**Design Review Committee
May 9, 2013**

SUBJECT: **Case 18465: Substantive Site Plan Approval – Mixed-Use
Development, 5504 Spring Garden Road, Halifax**

Case 18465
 Attachment A - Site Plan Approval Plans

A106

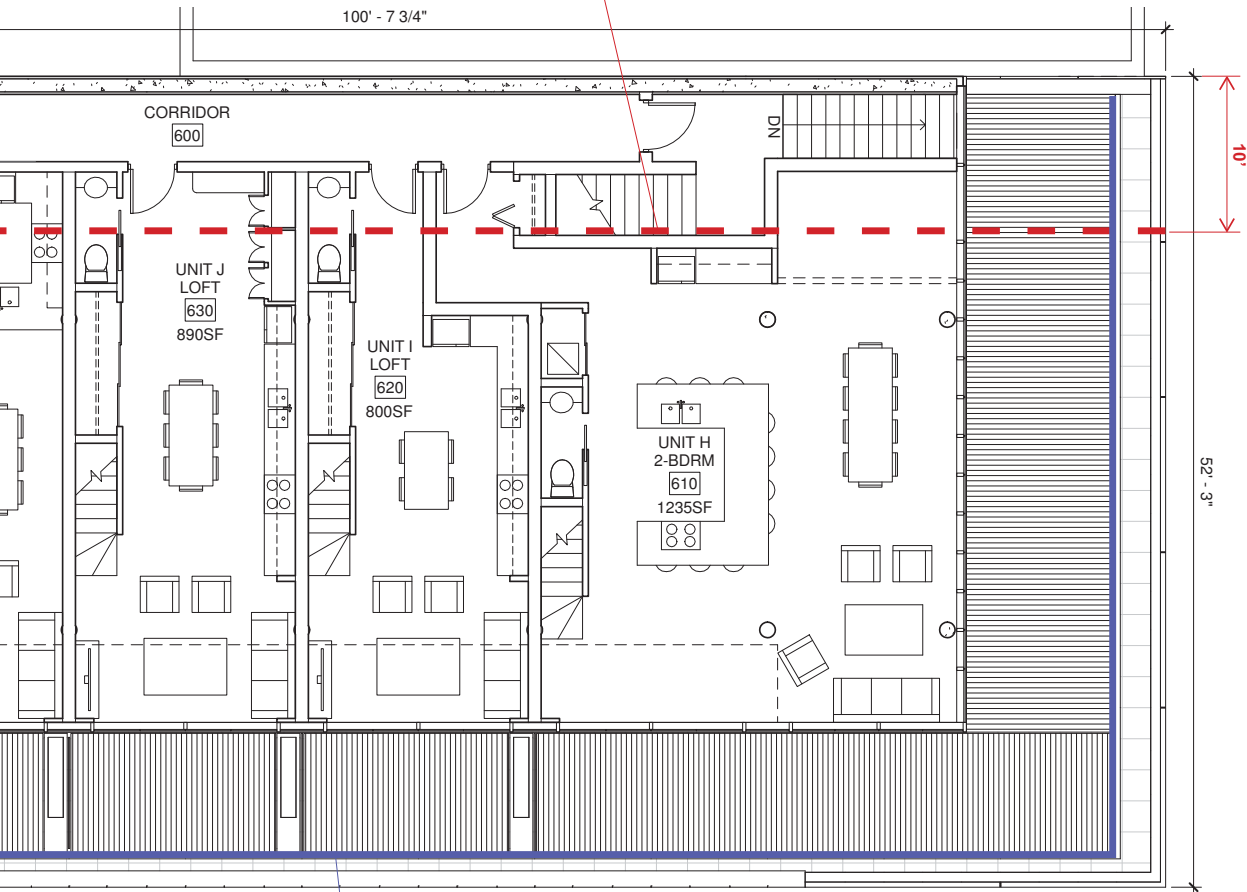
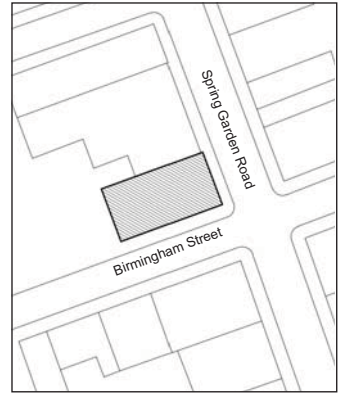
An upper storey streetwall stepback variance is sought under Section 3.6.5 of the Design Manual to allow for the installation of a glass guardrail behind the parapet along Spring Garden Road and Birmingham Street.

An upper storey side yard stepback variance is sought under Section 3.6.6 of the Design Manual to allow interior access and egress to both levels (floors 6 & 7) of the penthouse. The angular stepback above the streetwall from Spring Garden Road (southern sunlight angle), coupled with the upper storey stepbacks from all streetwalls, causes significant challenges with providing proper interior access and egress for these levels (i.e., required elevators and stairwells).

VARIANCE REQUEST 3:
TO WAIVE MID-RISE INTERIOR LOT
LINE SETBACK

VARIANCE REQUEST 2:
TO WAIVE 3 METRE STEPBACK RE-
QUIREMENT FOR OBJECTS ABOVE
STREETWALL TO ALLOW FOR GLASS
GUARDRAILS WHERE SHOWN

This variance request is reasonable given that the guardrail allows the terrace above the parapet to be used as outdoor amenity space. Without the variance, the guardrail must meet the 3 metre minimum stepback from the streetwall, which would eliminate most of the outdoor amenity space on the 6th level.

This variance request is reasonable given the small size of this lot and the challenges with providing building access to a small floor plate recessed above the streetwall. The design responds by providing these necessary building features within the required minimum stepback from interior lot lines, and away from the streetwall.

A107

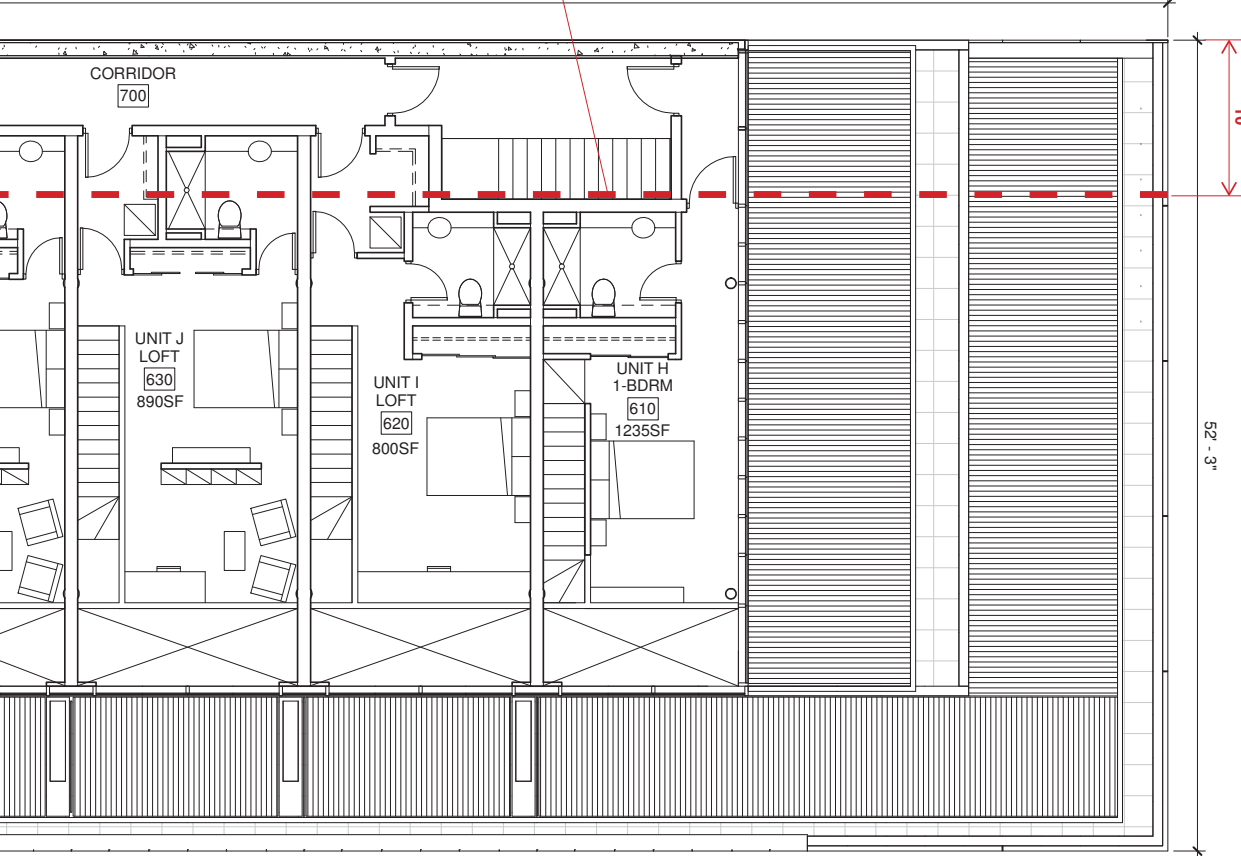
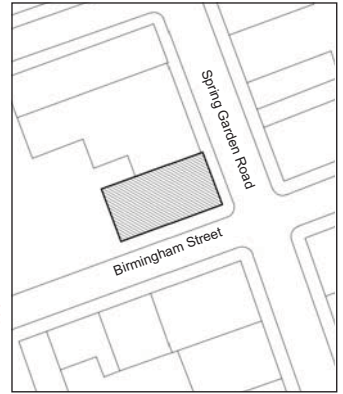
VARIANCE REQUEST 3:
TO WAIVE MID-RISE INTERIOR LOT
LINE SETBACK

3) Section 10(4) and (5) – Mid-Rise Building Setbacks and Stepbacks

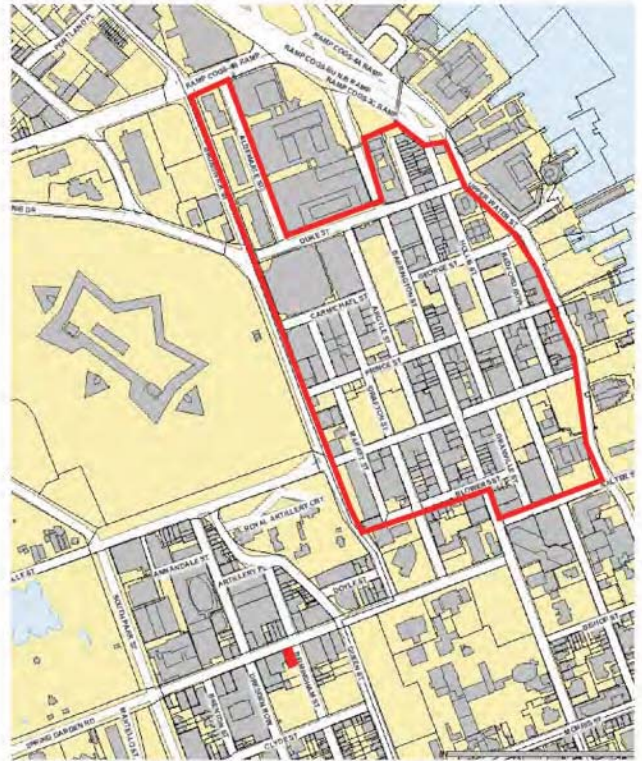
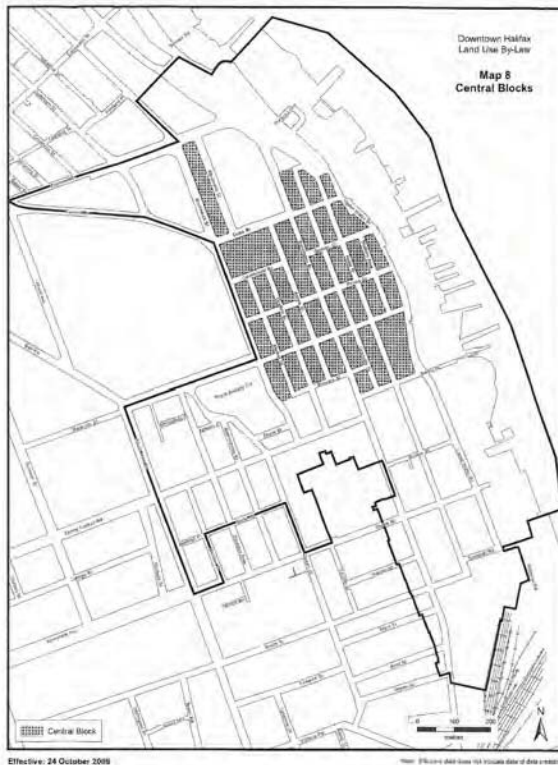
At issue are the 3m Interior Lot Line Setbacks required for the Mid-Rise portion of the building called for in Section 10(4).

A variance is being sought, as permitted by Section 10(14) to waive the setback requirement along BOTH the southern and western interior lot lines.

The major reason for this is that these setbacks are at odds with sound architectural space planning principles. On smaller lots – which this proposed project definitely is, with a dimension of 50'x100', building circulation elements – stairs, corridors, and elevators – are best located along an interior lot line and stacked in plan, allowing for structural economy and maximizing leasable space. Shifting these elements in plan as one moves up the building is an expensive – and ill-advised – option. It's quite easy to see how quickly the viable leasable space is reduced when setbacks are applied to all four lot lines – especially on a lot of this size.
